NextEra Energy Canada, ULC  
Goshen Wind Energy Centre

## **Natural Heritage Assessment and Environmental Impact Study Report Addendum**

60155032

January, 2013

**AECOM** Figure 1A

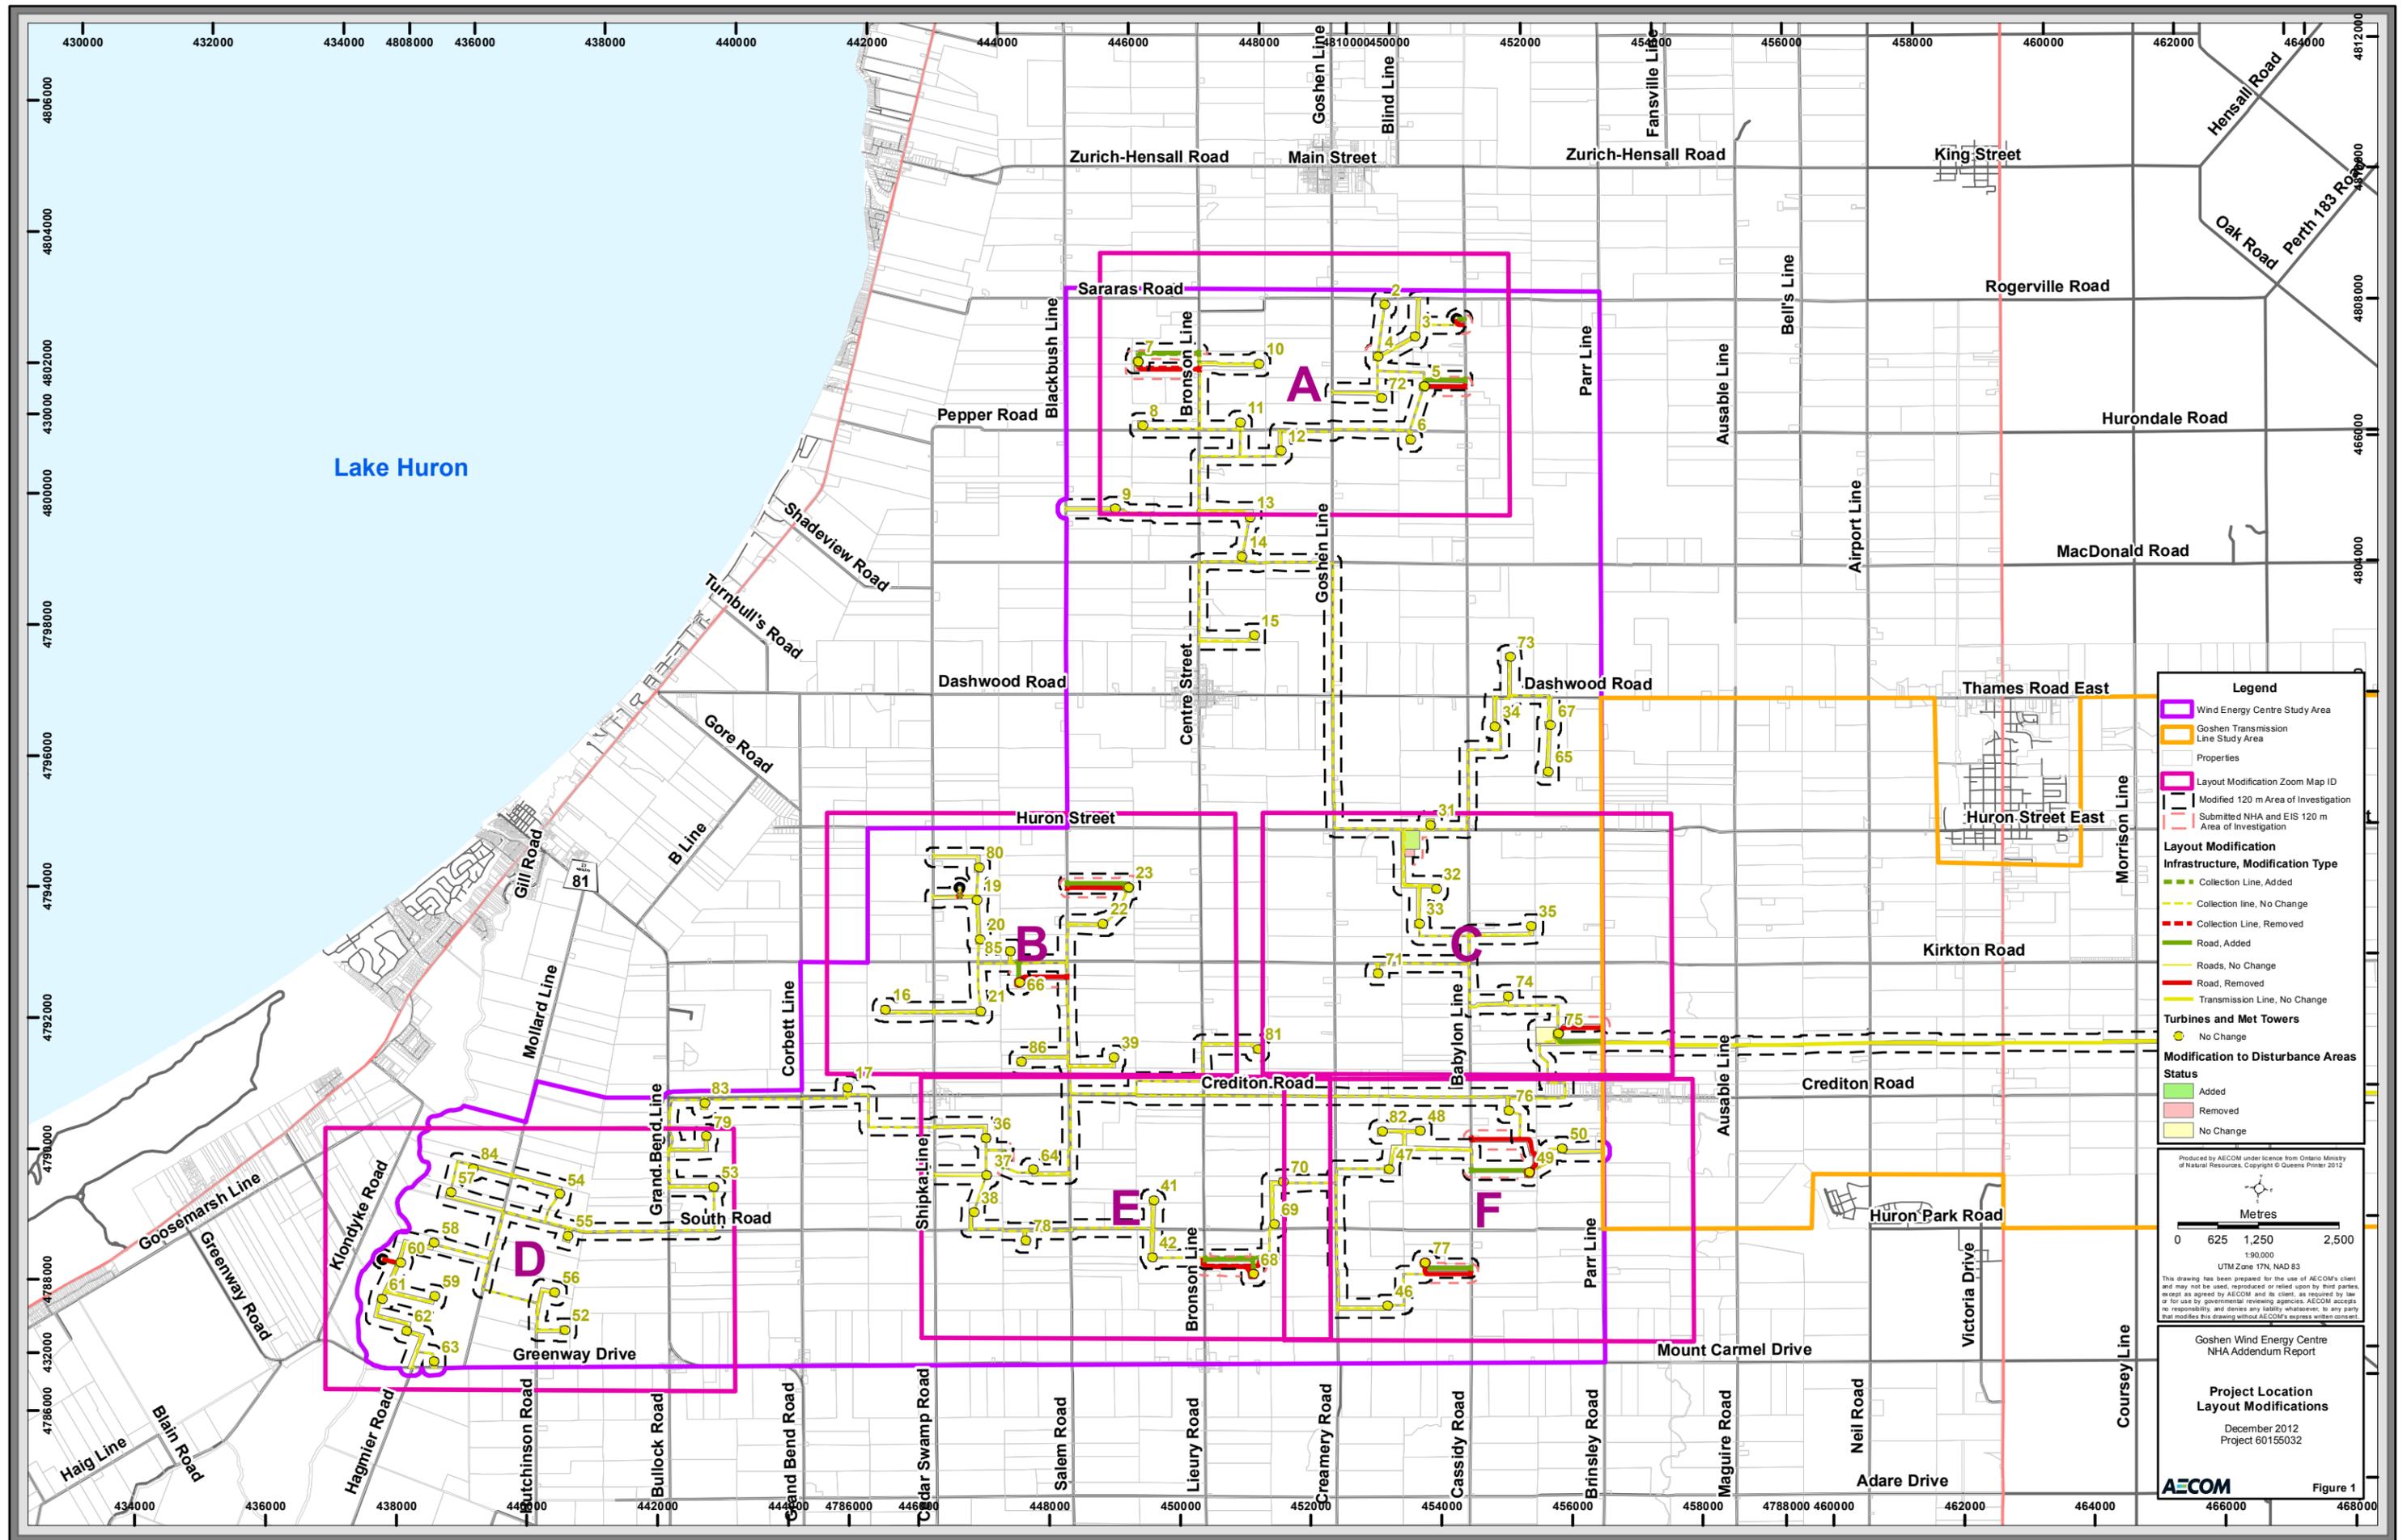
Modification ID	Feature(s) Potentially Affected by Proposed Modification (Change in Minimum Distance to Modified Project Component)	Map
<b>A1:</b> Relocation of access road and collection line to Turbine 7 to northern property line. Collection line extended north within the road right-of-way.	Natural Area 370 is no longer within 120 m of the Project Location. Features within 120 m of this modification include: <ul style="list-style-type: none"> <li>• Woodland Feature WOD-307 (increased from 102 m to &gt;120 m).</li> </ul>	Figure 1A
<b>A2:</b> Relocation of access road to meteorological tower to the north.	None	Figure 1A
<b>A3:</b> Disturbance area for construction of Turbine 4 extended to northern property line.	Disturbance area remains within 120 m of Natural Area 375. Features within 120 m of this modification include: <ul style="list-style-type: none"> <li>• Wetland Feature WET-025 (no change);</li> <li>• Woodland Feature WOD-312 (no change);</li> <li>• Confirmed Significant Wildlife Habitat: <ul style="list-style-type: none"> <li>◦ Plant Species of Conservation Concern Habitat Feature SCP-17 (no change);</li> </ul> </li> <li>• Generalized Candidate Significant Wildlife Habitat (Amphibian Breeding Habitat (Woodland), Plant Species of Conservation Concern Habitat, Bird Species of Conservation Concern Habitat) (no change).</li> </ul>	Figure 1A

<b>A4:</b> Relocation of access road to Turbine 5 to northern property line.	Access road remains within 120 m of Natural Area 379. Features within 120 m of this modification include: <ul style="list-style-type: none"> <li>• Woodland Feature WOD-331 (no change);</li> <li>• Valleyland Feature VAL-02 (reduced from 89 m to 82 m);</li> <li>• Candidate Significant Wildlife Habitat: <ul style="list-style-type: none"> <li>◦ Amphibian Wetland Breeding Habitat Feature AWE-29 (increased from 23 m to 73 m);</li> <li>◦ Deer Winter Congregation Area Feature DWC-01 (no change);</li> <li>◦ Deer Movement Corridor Feature WOD-331 (no change);</li> </ul> </li> <li>• Generalized Candidate Significant Wildlife Habitat (Woodland Area-Sensitive Bird Breeding Habitat, Woodland Raptor Nesting Habitat, Bird Species of Conservation Concern Habitat) (no change).</li> </ul>	Figure 1A

Due to modification A1, natural area 370 is no longer within 120 m of the Project Location (refer to Figure 1A); consequently, woodland WOD-307 is removed from consideration in this NHA Addendum.

**AECOM** Figure 1C

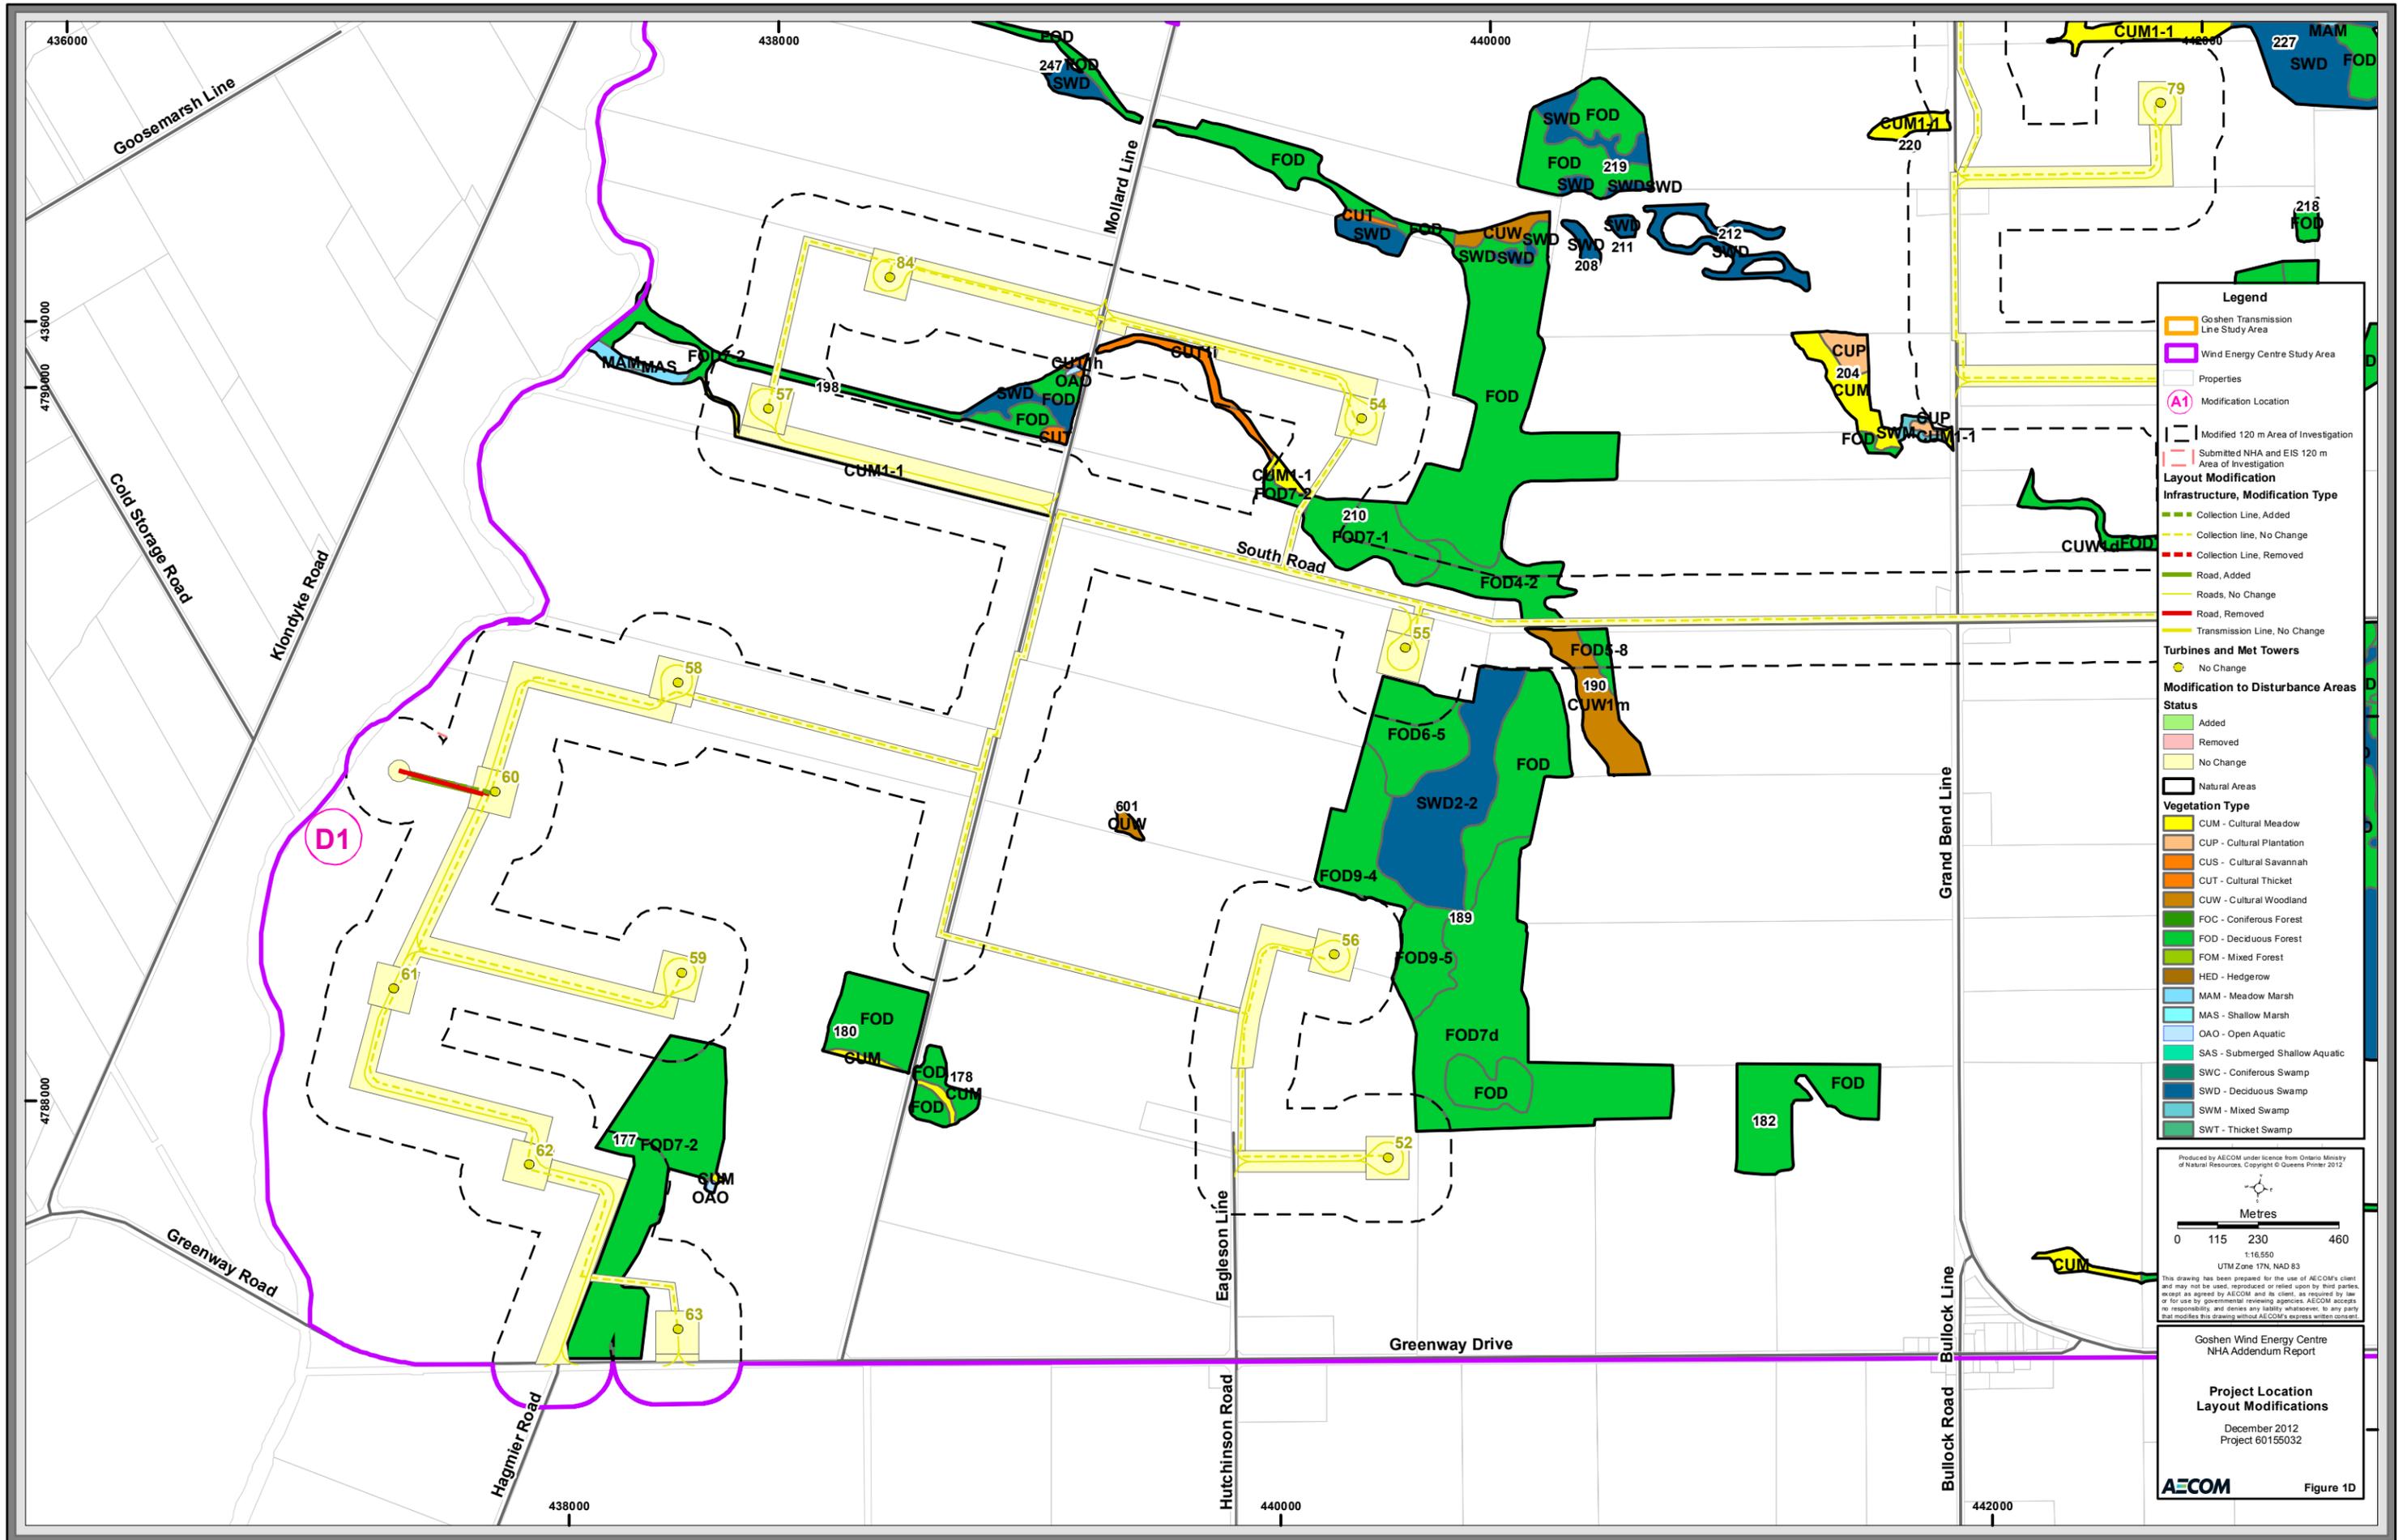
<b>B3:</b> Relocation of access road to Turbine 66, to extend north to Kirkton Road.	Access road is no longer within 120 m of Natural Area 266. Features within 120 m of this modification include: <ul style="list-style-type: none"> <li>• Wetland Feature WET-019 (increased from 111 m to &gt;120 m);</li> <li>• Woodland Feature WOD-131 (increased from 44 m to &gt;120 m);</li> <li>• Generalized Candidate Significant Wildlife Habitat (Woodland Area-Sensitive Bird Breeding Habitat, Bird Species of Conservation Concern Habitat, Turtle Wintering Area, Seeps and Springs, Amphibian Breeding Habitat (Woodland), Plant Species of Conservation Concern Habitat, Insect Species of Conservation Concern Habitat, Woodland Raptor Nesting Habitat, Bat Maternity Colony) (increased from 44 m to &gt;120 m).</li> </ul>	Figure 1B
<b>C1:</b> Modification of construction laydown yard to be a square instead of rectangular area.	None	Figure 1C

<b>C2:</b> Relocation of access road and collection line to Turbine 75 to southern property line.	None	Figure 1C
<b>D1:</b> Minor realignment of access road to meteorological tower.	None	Figure 1D
<b>E1:</b> Relocation of collection line between Turbines 36, 37 and 64, to run adjacent to boundary of natural area 236.	Collection line remains within 120 m of Natural Area 236. Features within 120 m of this modification include: <ul style="list-style-type: none"> <li>• Wetland Feature WET-010 (reduced from 3 m to &gt;0.1 m);</li> <li>• Woodland Features WOD-044 (increased from 30 m to 33 m) and WOD-054 (no change);</li> <li>• Candidate Significant Wildlife Habitat: <ul style="list-style-type: none"> <li>◦ Bat Maternity Colony Feature BMC-236 (no change);</li> </ul> </li> <li>• Generalized Candidate Significant Wildlife Habitat (Mature Forest Stand, Amphibian Breeding Habitat (Woodland), Amphibian Breeding Habitat (Wetland), Bird Species of Conservation Concern Habitat, Plant Species of Conservation Concern Habitat, Insect Species of Conservation Concern Habitat) (no change).</li> </ul>	Figure 1E
